**HISTORIC PRESERVATION BOARD  
CITY OF PORTLAND, MAINE**

**WORKSHOP – ADVISORY REVIEW  
222 ST. JOHN STREET**

**RE:** April 18, 2018 – **Workshop** – Advisory Design Review of Proposed Parking Garage

**Address:** 222 St. John Street  
(project site is located within 100 ft. of Maine Central Railroad Office Building, an individually designated landmark structure)

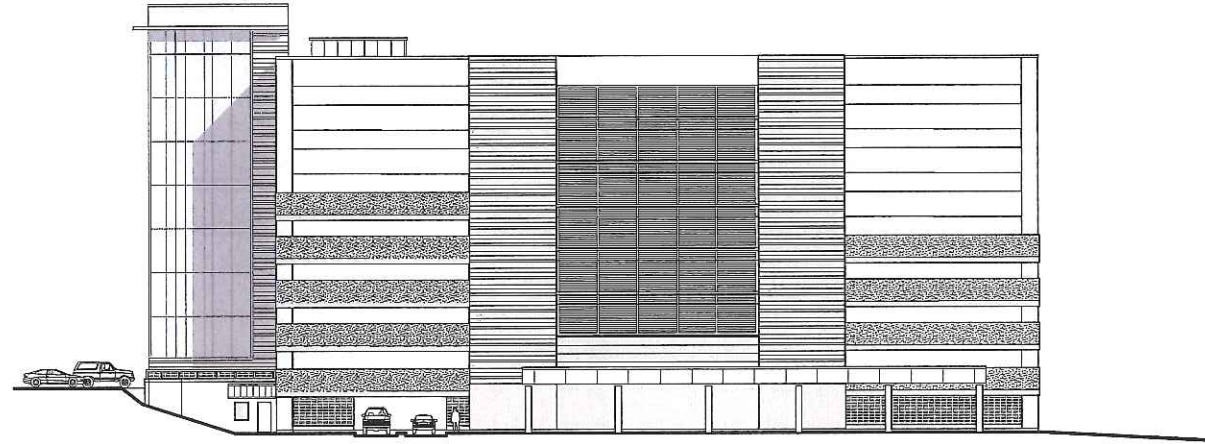
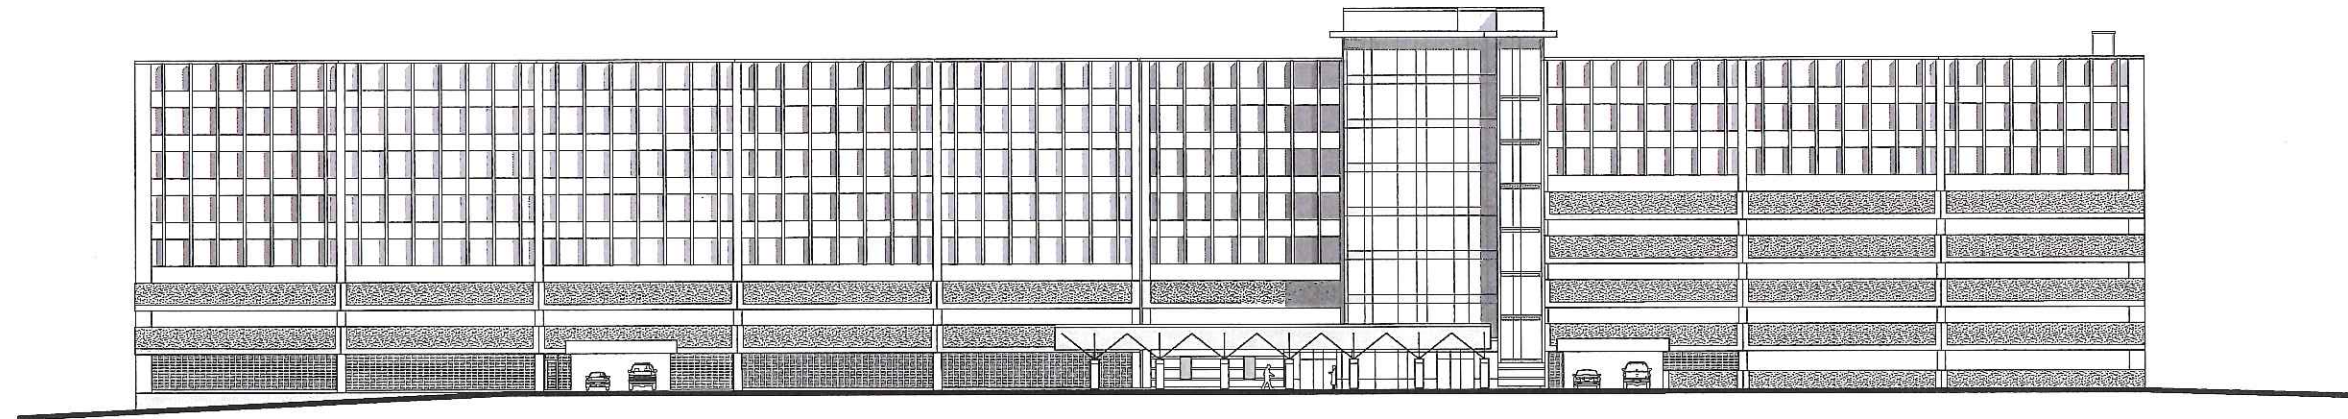
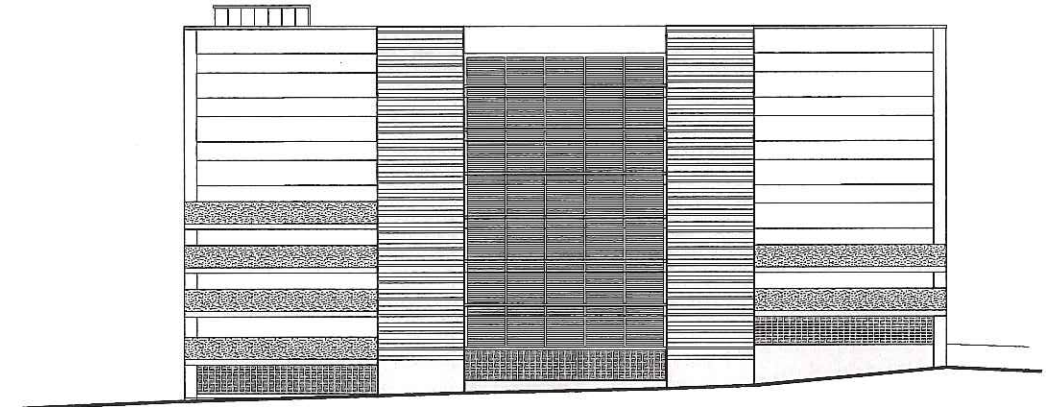
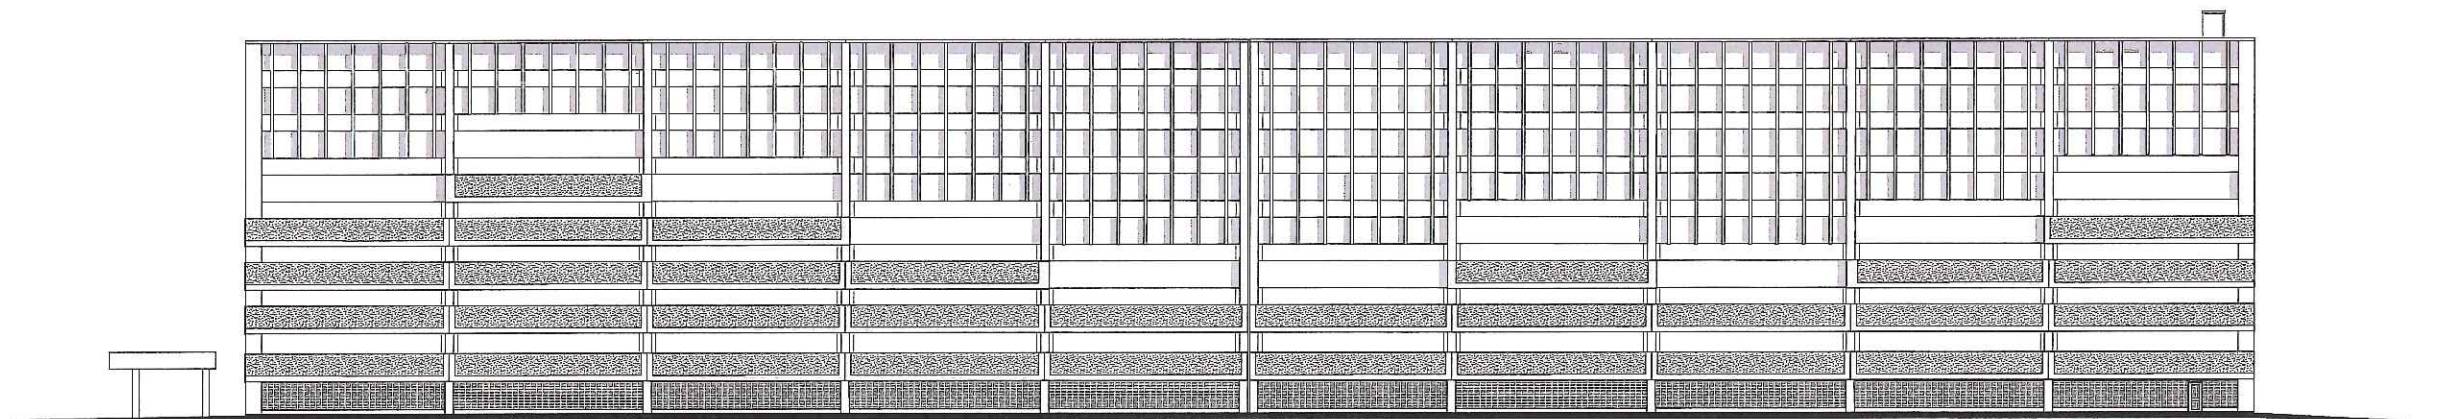
\*Given the fact that the north elevation of the garage will have the most direct visual relationship with the MCRR office building, how does the new structure relate to the rear elevation of the historic structure? Are there ways that the two elevations might better relate?

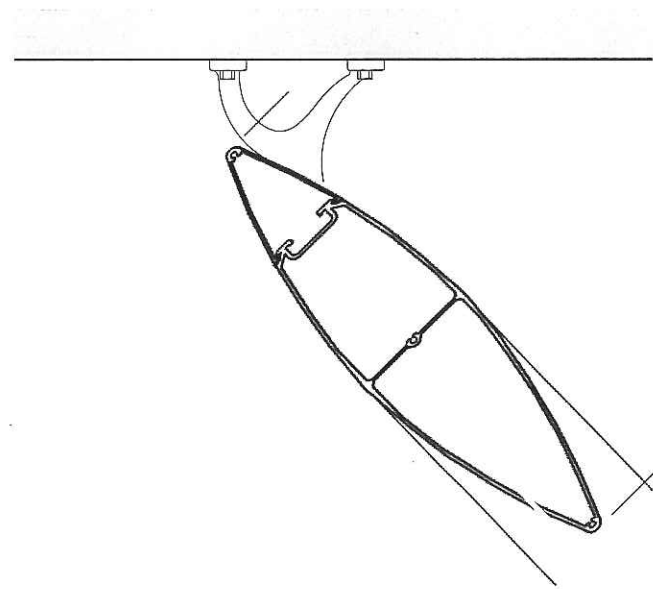
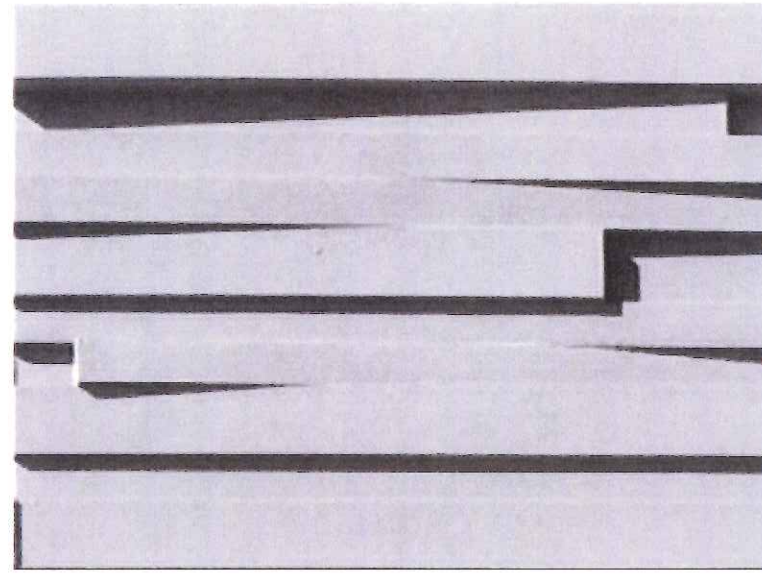
Are the proposed exterior materials of high quality and are they likely to age well? Is the color or tone of the material palette compatible with the historic structure and/or larger context?
